IV. RESPONSES TO COMMENTS ON THE DRAFT EIR

RESPONSES TO DRAFT EIR COMMENT LETTERS

Daily Vehicle Trips on 23rd Street North of Airport Avenue

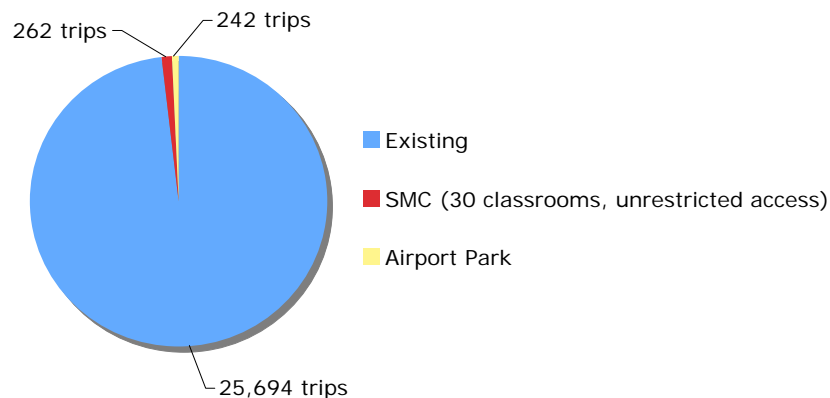
Comment: Figure 7 in the Kaku November 2004 Site Access and Circulation Plan shows 12% of students traveling to and from the northwest via surface streets, and 7% of students traveling to and from the southwest via surface streets. That adds up to 19% traveling to and from the west. 19% of 5,317 daily car trips (the Kaku estimate for 2010 for the Bundy Campus) is 1010 daily car trips. It is difficult to understand how the college could recommend full access to Airport Ave., and then come up with a resulting increase of 165 plus 18, rather than 1010 daily car trips.

Provided below is a visual diagram of existing and projected vehicle trips on 23rd Street north of Airport Avenue:

While the Draft EIR concluded that traffic impacts would be identical for all Access Alternatives (except for Access Alternatives C1 and C2 which would result in one additional street segment impacted), the Draft EIR did not conclude that all environmental impacts would be identical for all of the Project Alternatives studies. As is described in Section V (Alternatives to the Master Plan), the Draft EIR concluded that the Renovated East Building Alternative would have the fewest environmental impacts of all the Project Alternatives analyzed, although it would not satisfy the project objectives as fully as the Master Plan.

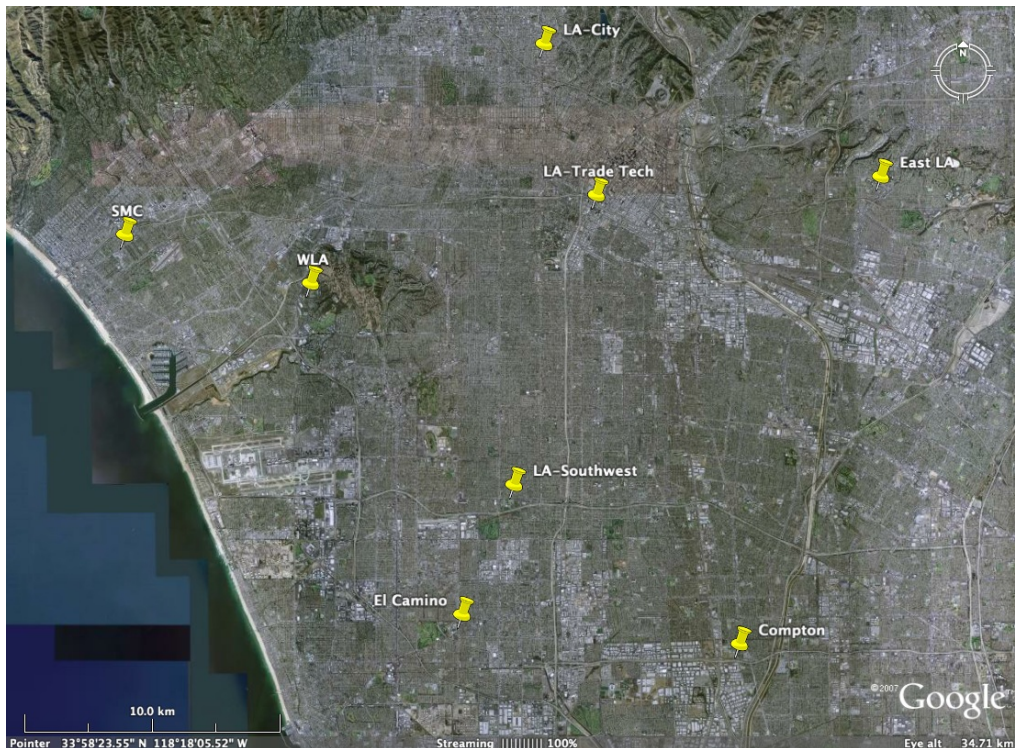
The Santa Monica Community College District, which consists of Malibu and Santa Monica (combined population ca. 100,000) had a total enrollment on September 20, 2006 of 29,960. (<http://www.smc.edu/research/>) 83% of SMC students live in Los Angeles and could just as easily attend classes at West L.A. or one of the other L.A. campuses, if the LACCD advertised as aggressively as SMC does.

But for the college to continue to expect us to quietly accept more and more students, and more and more traffic, negatively impacting the quality of life in our neighborhoods, when only 17% of SMC students live in Santa Monica or Malibu, I feel is above and beyond the call of duty.
